To: INCITS T10 Committee  
From: Matthew Bondurant, Quantum  
Date: 29 June 2004  
Document: T10/04-200r0  
Subject: Modify ADT ACK and NAK to differentiate Initiate Recovery acknowledgements

#### B.11 Delayed response with recovery driven by timeout

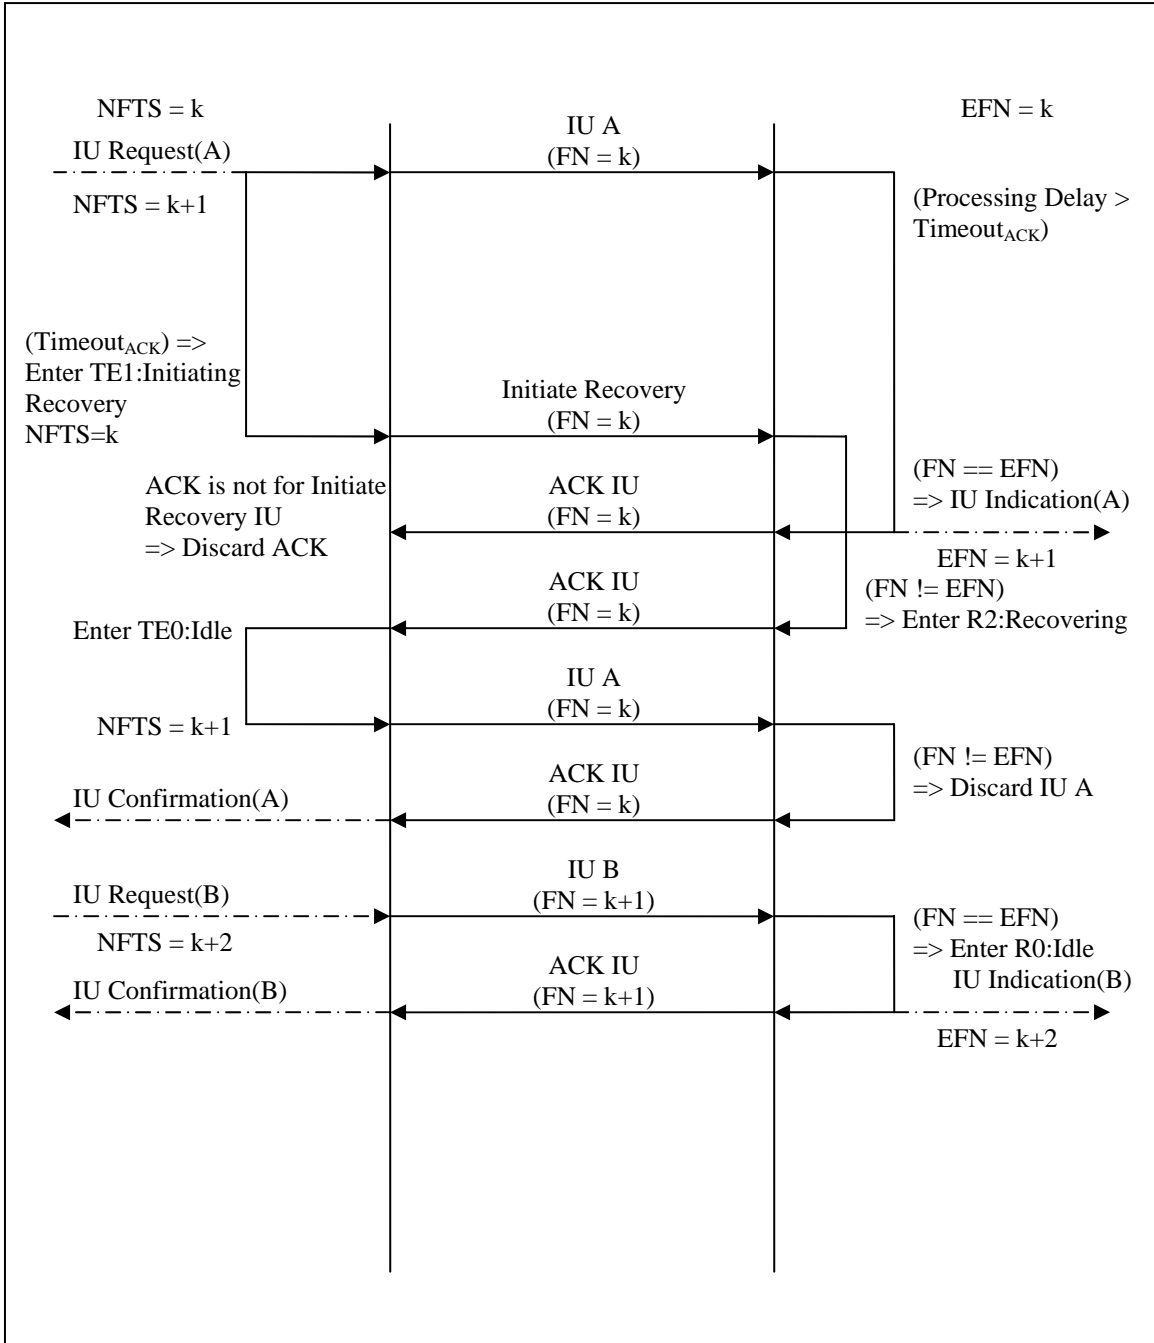
The following sequence shows how the error scenario posed in the statement above would be handled after implementing one of the solutions discussed below. This scenario could be added to appendix B as follows:

Figure B.11 shows a scenario in which the recipient of a frame is delayed in processing the frame by some other factor in the device. It is the timeout on the ACK which begins the error recovery sequence.
